SUBJECT: Calvert Cliffs Nuclear Power Plant
Unit Nos. 1 & 2; Docket Nos. 50-317 & 50-318
Core Operating Limits Reports for Unit 1, Cycle 15, Revision 5 and Unit 2,
Cycle 14, Revision 2

UNIT 1, CYCLE 15, REVISION 5

UNIT 2, CYCLE 14, REVISION 2

Figure 3.2.1-1

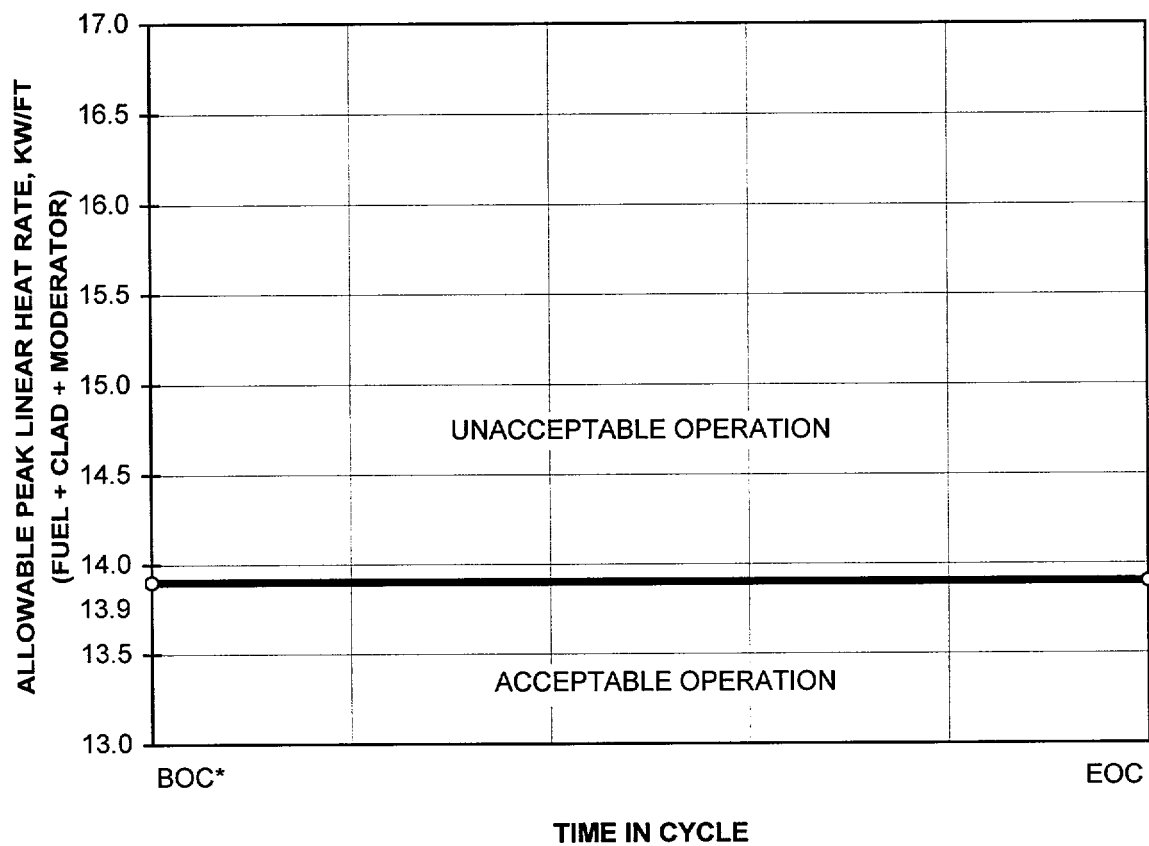
Figures 3.2.1-1 and 3.2.1-3 are revised to lower the allowable PLHR from 14.3 kw/ft to 13.9 kw/ft. Figures 3.2.1-3, 3.2.2, & 3.2.3 are revised to expand the tradeoff curves below 80% power. Finally, Figure 3.2.5 and the list of references are revised to implement the ABB-NV setpoints. (SE00451, Rev. 0000).

***Allowable PLHR was changed from 14.3 kw/ft to 13.9 kw/ft mid-cycle**

Figure 3.2.1-2

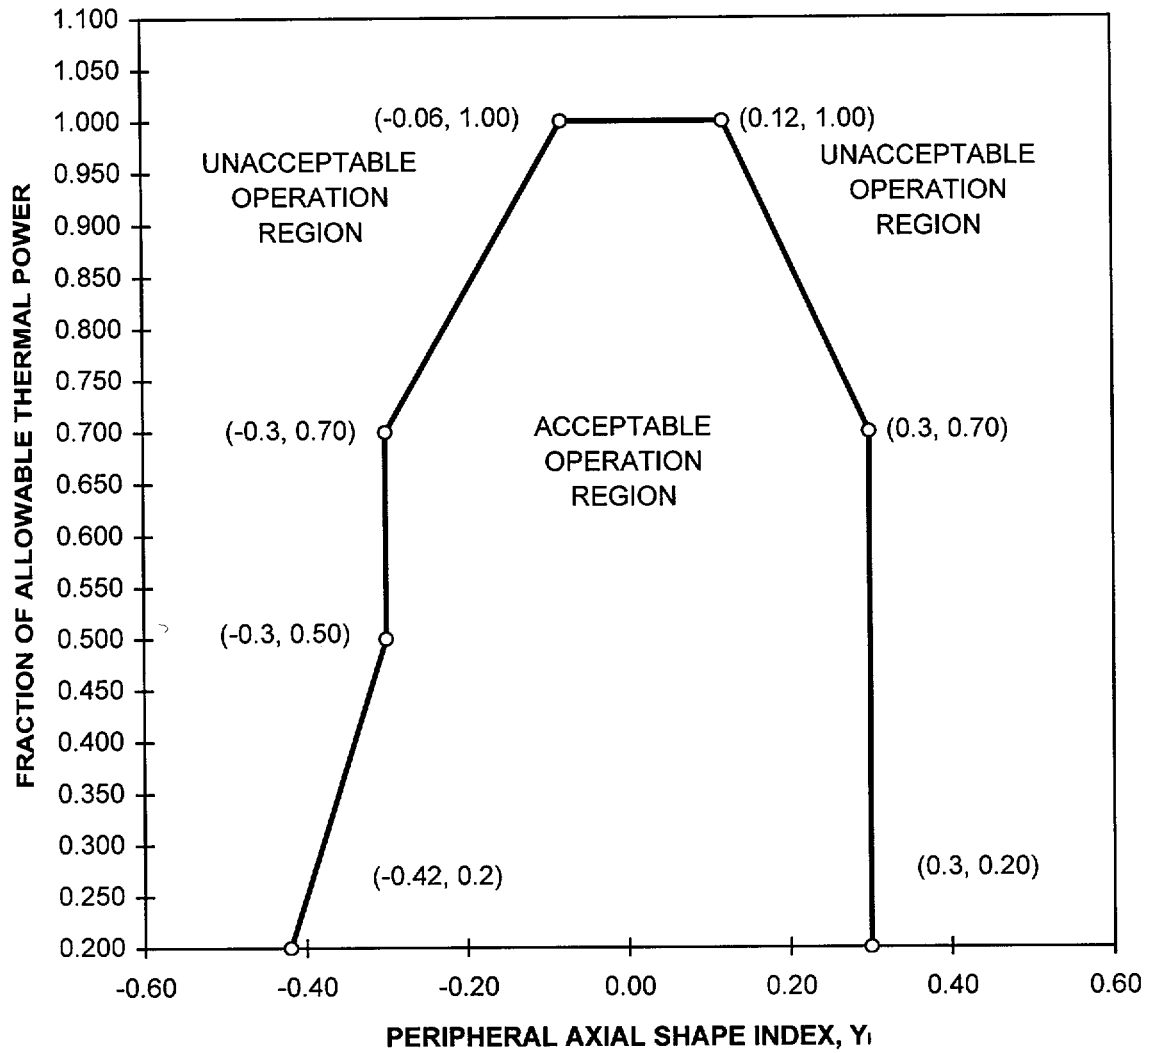
COLR Figures 3.2.1-2 & 3.2.5 are revised to reflect a 20% LCO monitoring floor for LHR and DNB ASI limits (SE00433, Rev. 0000).

Figures 3.2.1-2, 3.2.1-3, & 3.2.5 are revised to provide clarification in reference to NEOP-13. Section 3.2.1 & Figure 3.2.1-3 were also revised to provide clarity. Finally, Figures 3.2.2 & 3.2.3 were revised to correct an inaccuracy in the peaking factor Tech Specs (SE00451, Rev. 0000).

(LCO Limits are not needed below 20% thermal power)

Figure 3.2.3

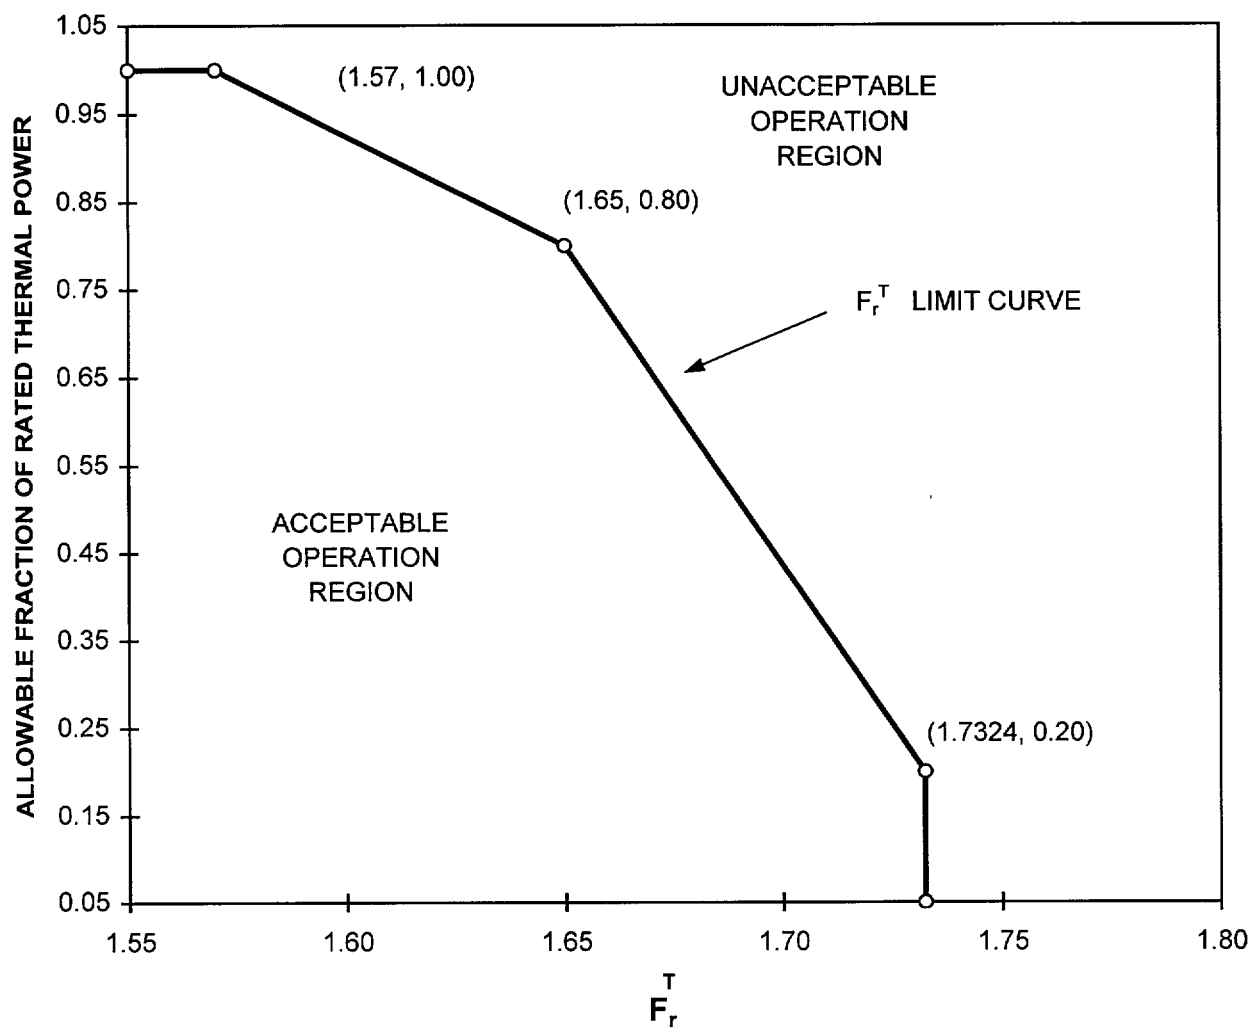
Figure 3.2.3 is revised to implement a more restrictive F_r^T due to ROPM issues discovered mid-cycle (SE00472, Rev. 0).

The calculated value of F_r^T shall be limited to ≤ 1.57 .

While operating with F_r^T greater than 1.57, withdraw CEAs to or above the Long Term Steady State Insertion Limits (Figure 3.1.6)

Figure 3.2.3

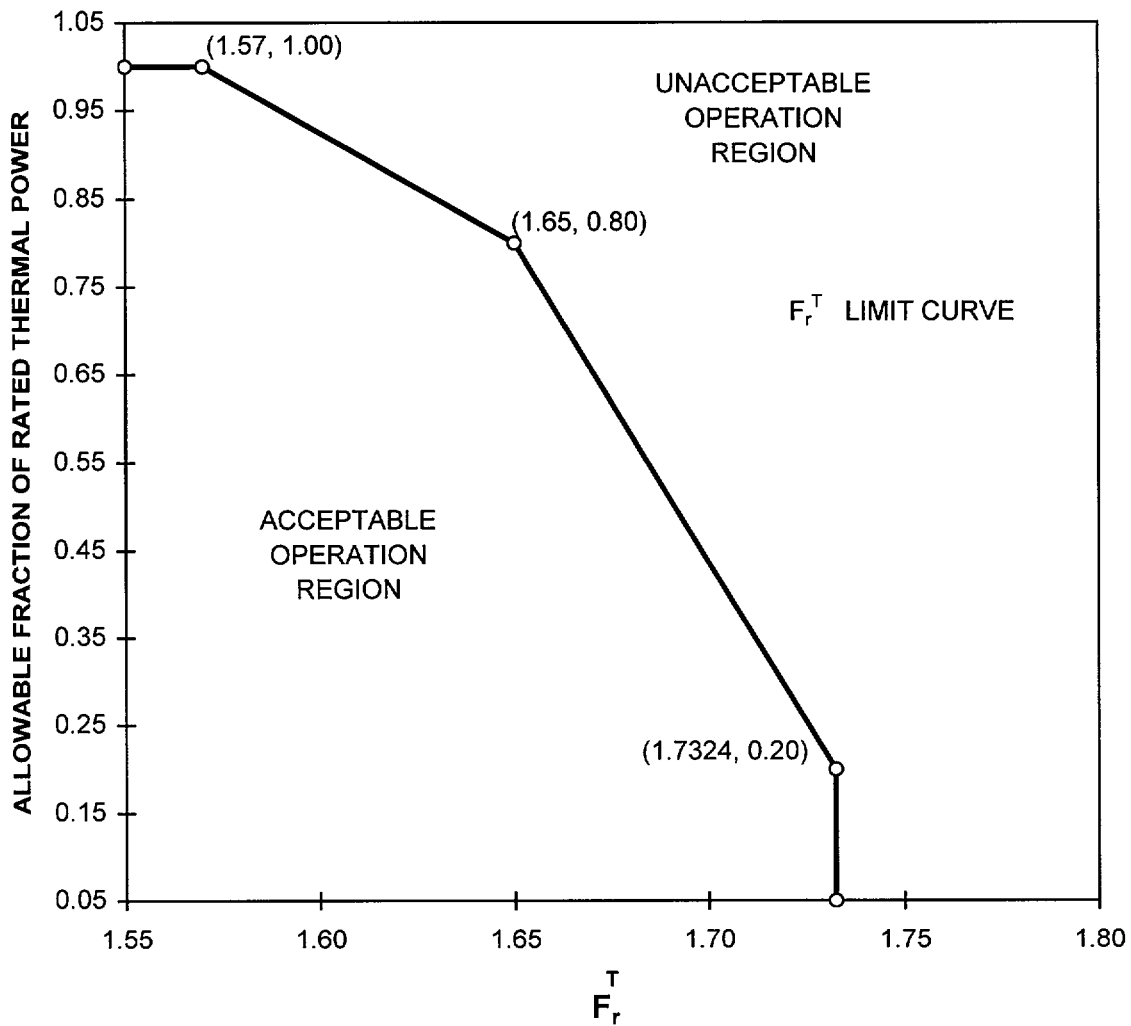
Figure 3.2.3 is revised to implement a more restrictive F_r^T due to ROPM issues discovered mid-cycle (SE00472, Rev. 0).

The calculated value of F_r^T shall be limited to ≤ 1.57 .

While operating with F_r^T greater than 1.57, withdraw CEAs to or above the Long Term Steady State Insertion Limits (Figure 3.1.6)
